# HISTORIC AND DESIGN REVIEW COMPLIANCE AND TECHNICAL ADVISORY BOARD

**HDRC CASE NO:** 2024-032  
**ADDRESS:** 103 FIR  
**LEGAL DESCRIPTION:** NCB 2966 BLK 1 LOT 9  
**ZONING:** RM-4, H  
**CITY COUNCIL DIST.:** 1  
**DISTRICT:** King William Historic District  
**APPLICANT:** Otoniel Trevino/STATT PROPERTIES INC  
**OWNER:** Otoniel Trevino/STATT PROPERTIES INC  
**TYPE OF WORK:** Conversion of an original window opening to a door opening  
**APPLICATION RECEIVED:** January 07, 2024  
**60-DAY REVIEW:** March 07, 2024  
**CASE MANAGER:** Edward Hall

The applicant is requesting a Certificate of Appropriateness for approval to convert an original window opening to a door opening on the front façade.

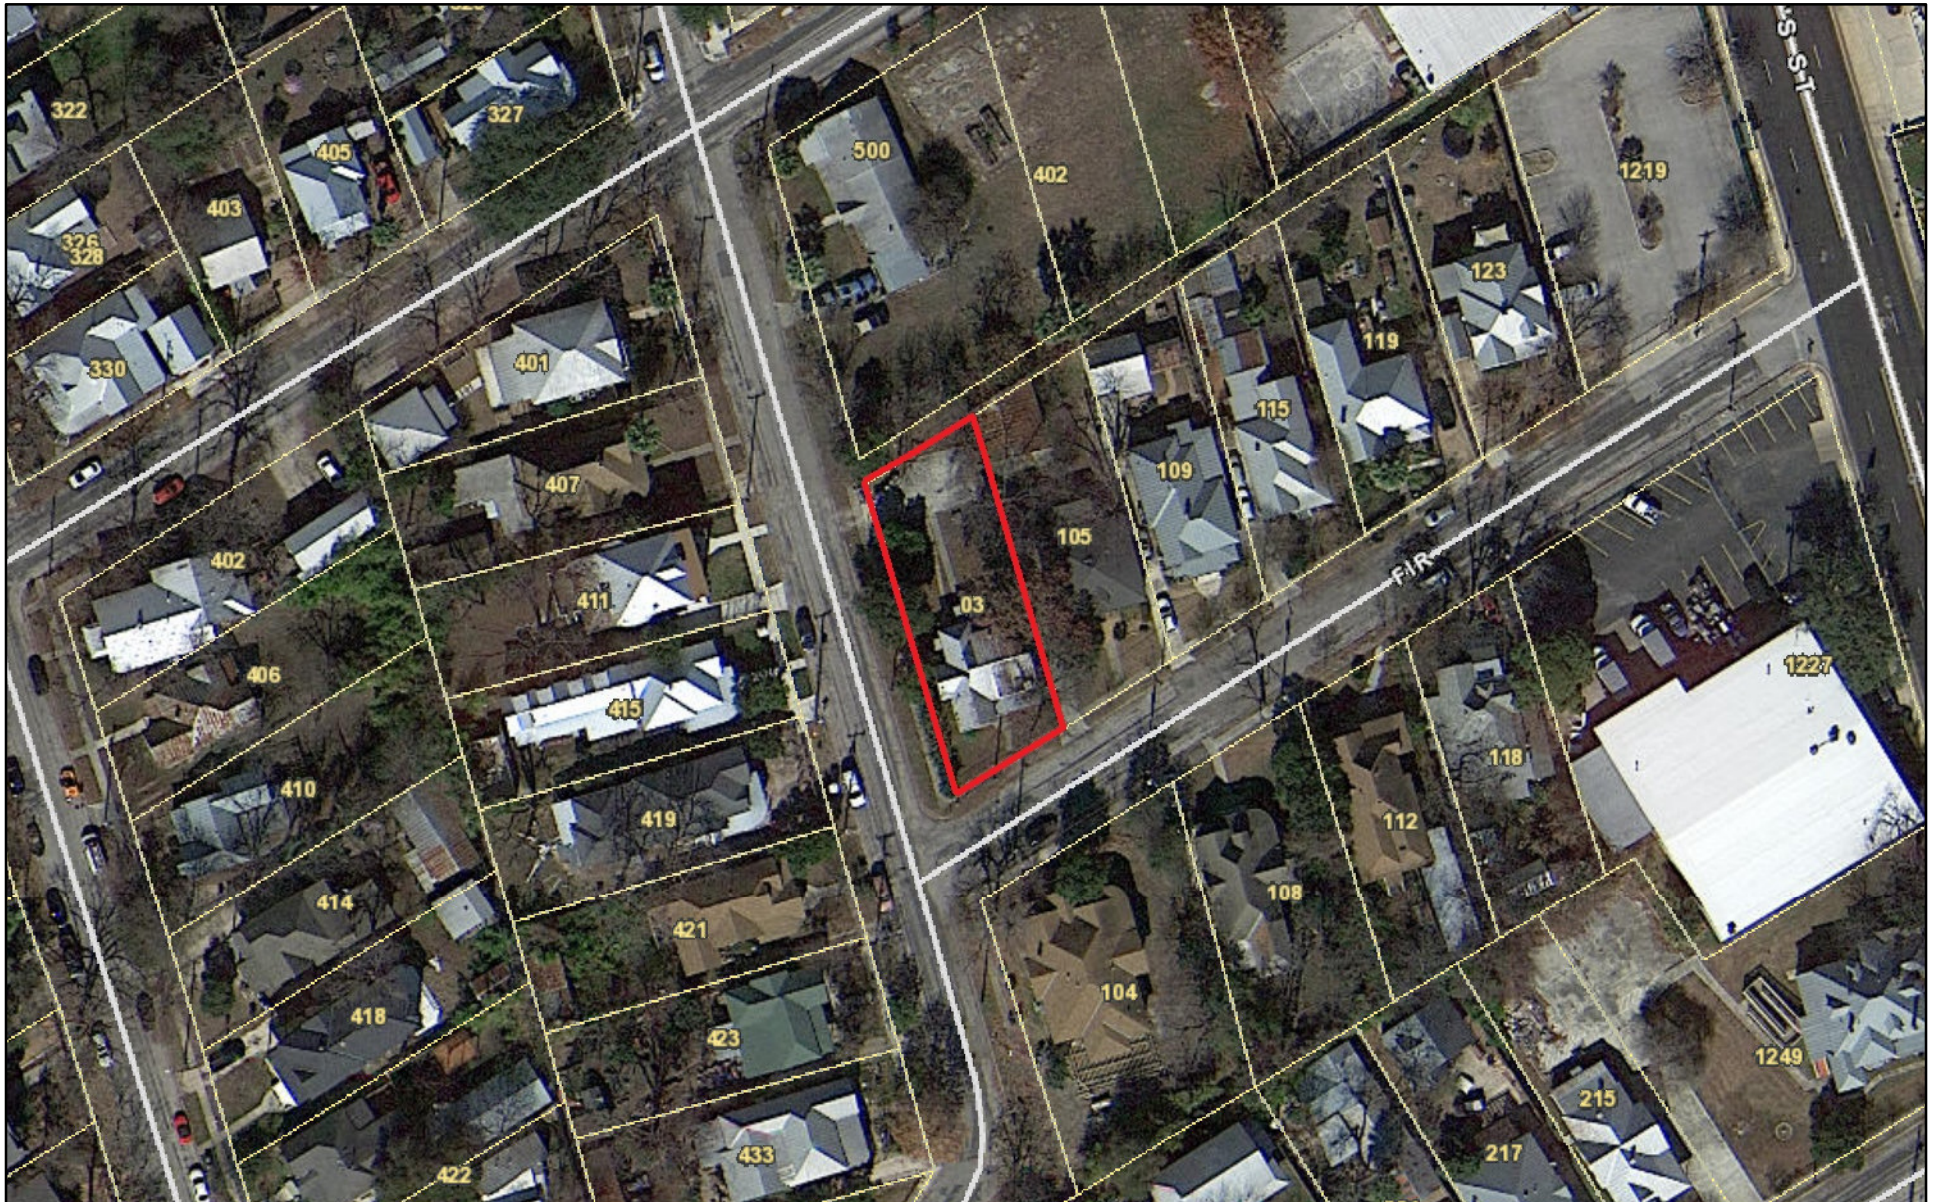
- c. MODIFICATION – The applicant has proposed to convert the existing window opening to a door opening. Per the Guidelines for Exterior Maintenance and Alterations 6.A.i. original window and door openings should be preserved. Additionally, the Guidelines note that applicants should avoid creating new primary entrances or window openings on the primary façade or where visible from the public right of way. Staff finds the proposed conversion from a window opening to a door opening to be inconsistent with the Guidelines for Exterior Maintenance and Alterations. Staff finds that the original window should be reinstalled, and the opening should return to its original size and profile.

- d. INSTALLED DOOR – The Guidelines for Exterior Maintenance and Alterations 6.B.i. notes that replacement doors and new doors in historic structures should match the size, material, and profile of the historic element. Staff finds that the installed door, a fiberglass door with an oval lite with faux divisions is not consistent with the Guidelines.

Staff does not recommend approval based on findings c and d. Staff recommends that the original window be reinstalled and that the opening should return to its original size and profile.

Should the Compliance and Technical Advisory Board find the proposed conversion to be appropriate, staff recommends the an architecturally appropriate wood door be installed. The door should be submitted to OHP staff prior to purchase and installation.

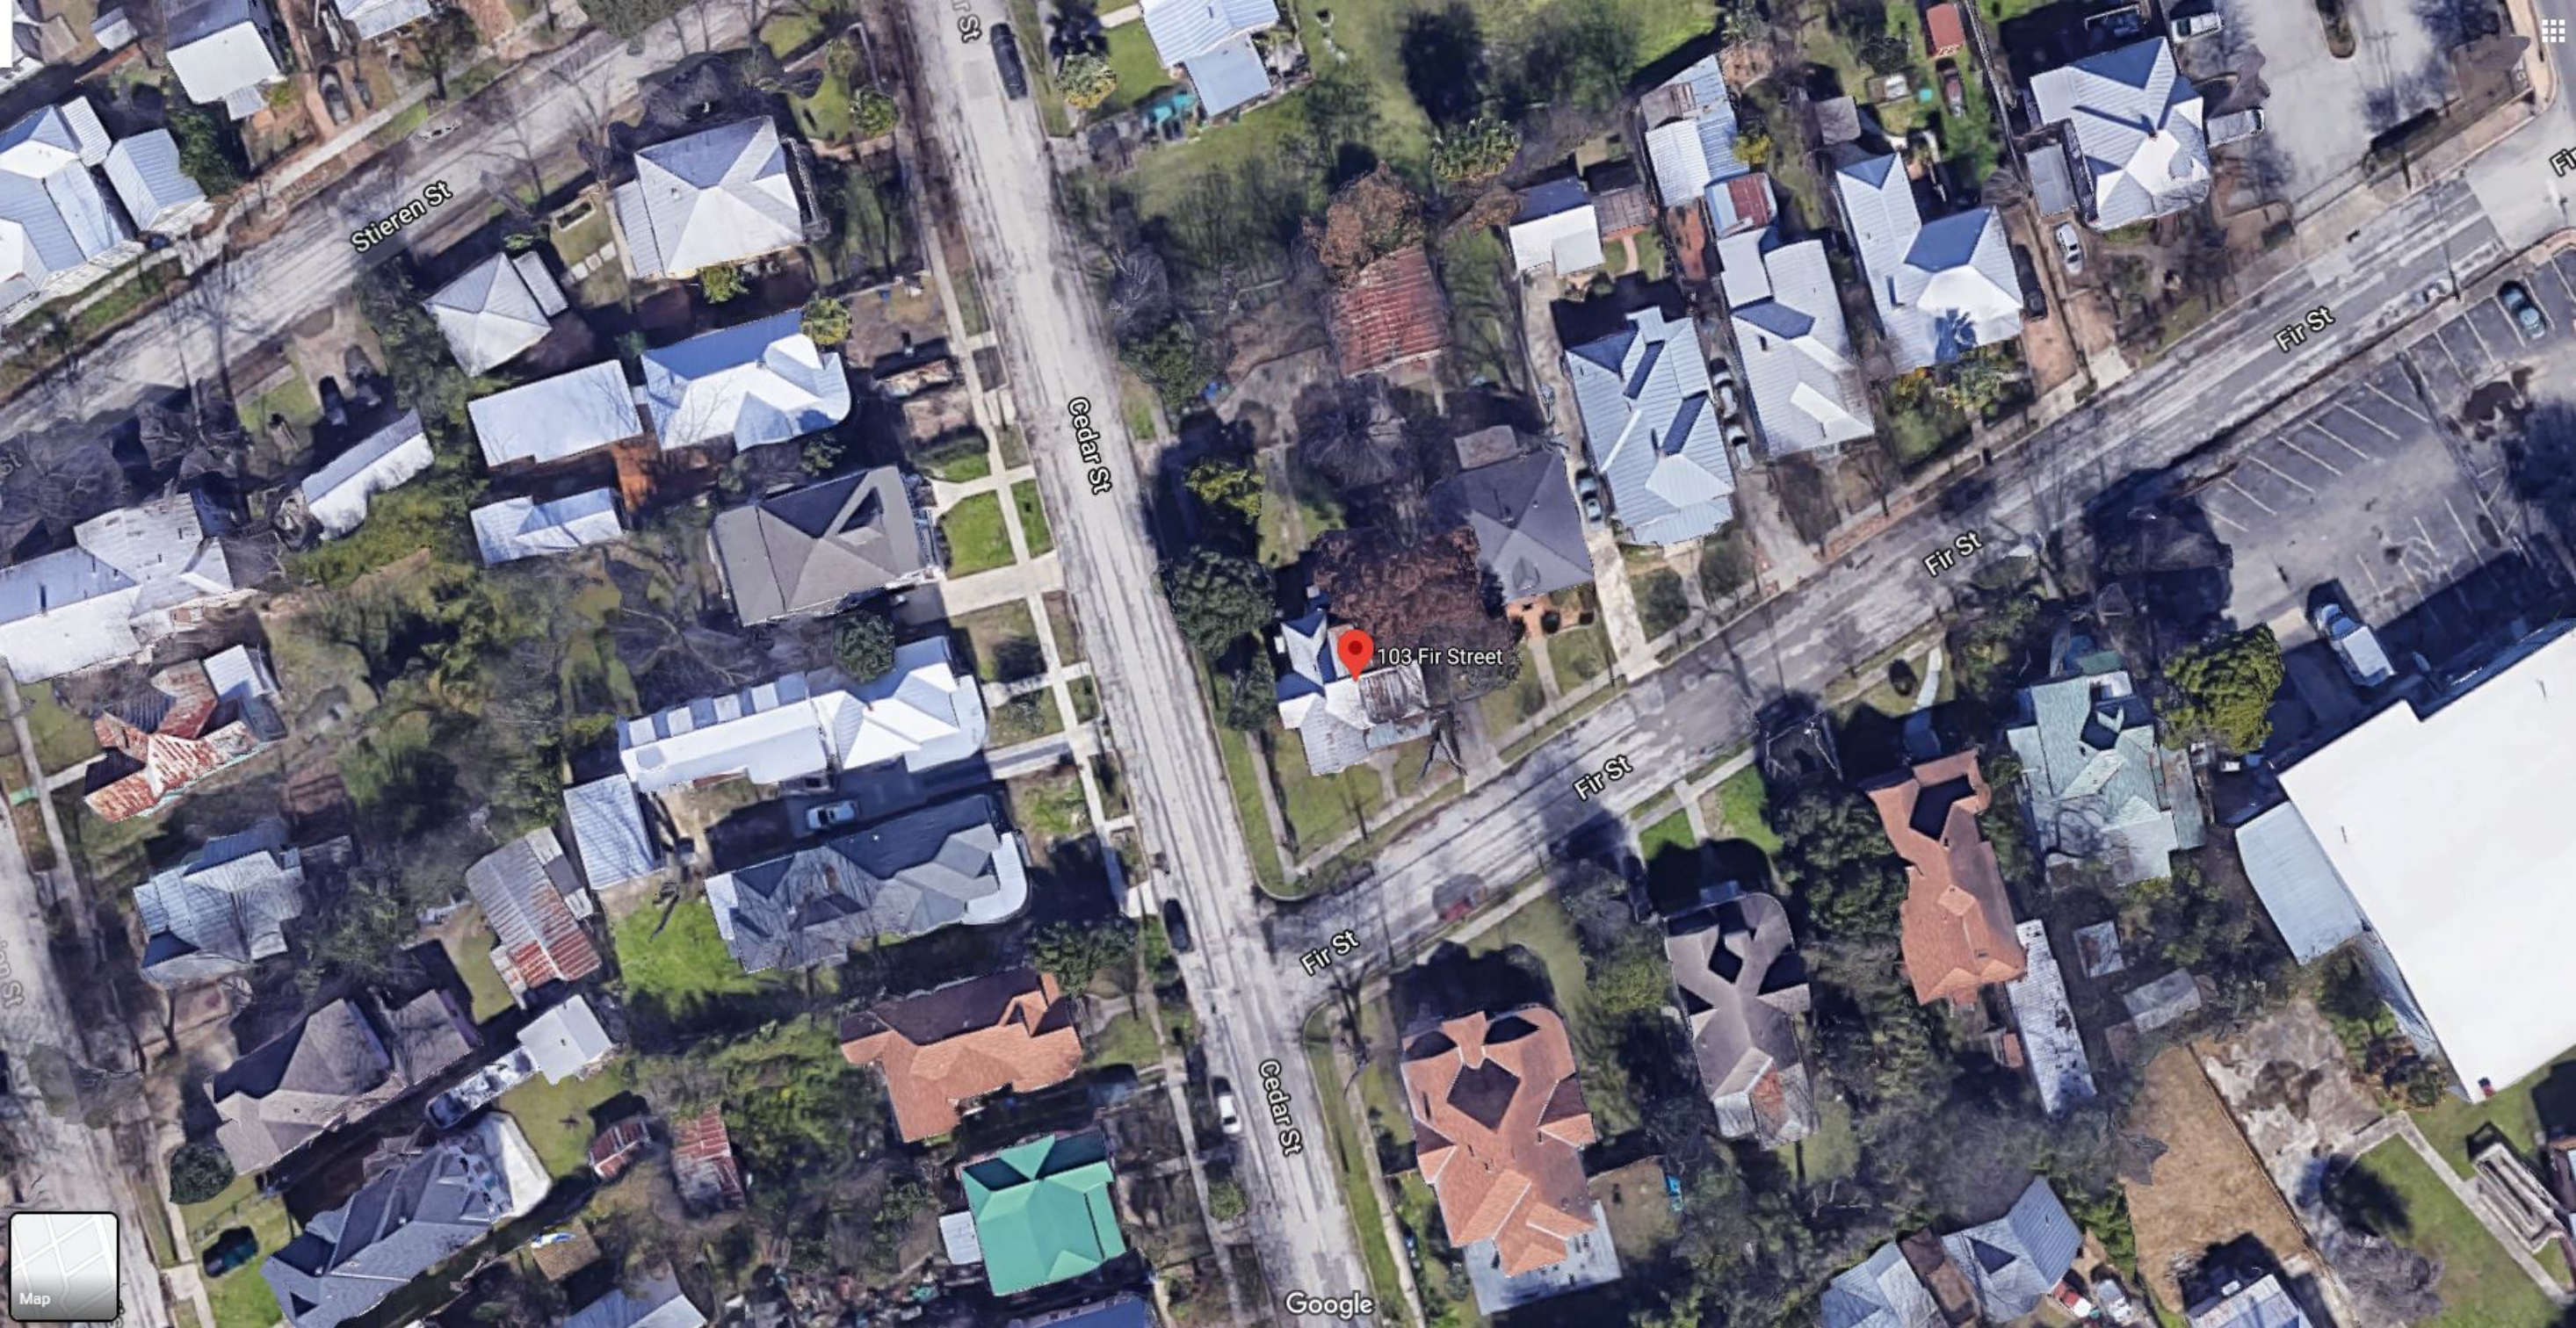
- c. FENESTRATION MODIFICATION – The applicant has proposed to replace the front-facing two-over-two wood sash window with an aluminum door with an oval light, faux leaded glass, and wood steps. Per the Guidelines for Exterior Maintenance and Alterations 6.A.i., applicant should preserve existing window and door openings, avoid enlarging or diminishing to fit stock sizes or air conditioning units, avoid filling in historic door or window openings, and avoid creating new primary entrances or window openings on the primary façade or where visible from the public right-of-way. Staff finds the proposed fenestration modification is in direct opposition of the Guidelines and should be reversed. If the commission is compelled to approve, staff finds a style-appropriate salvaged wood door should be used instead of the proposed aluminum and the new door opening should feature a matching wood screen as the original front door.

Staff does not recommend approval based on the findings; staff recommends the original fenestration should be restored. If the commission is compelled to approve, staff finds a style-appropriate salvaged wood door should be used instead of the proposed aluminum and the new door opening should feature a matching wood screen as the original front door.

Denied.
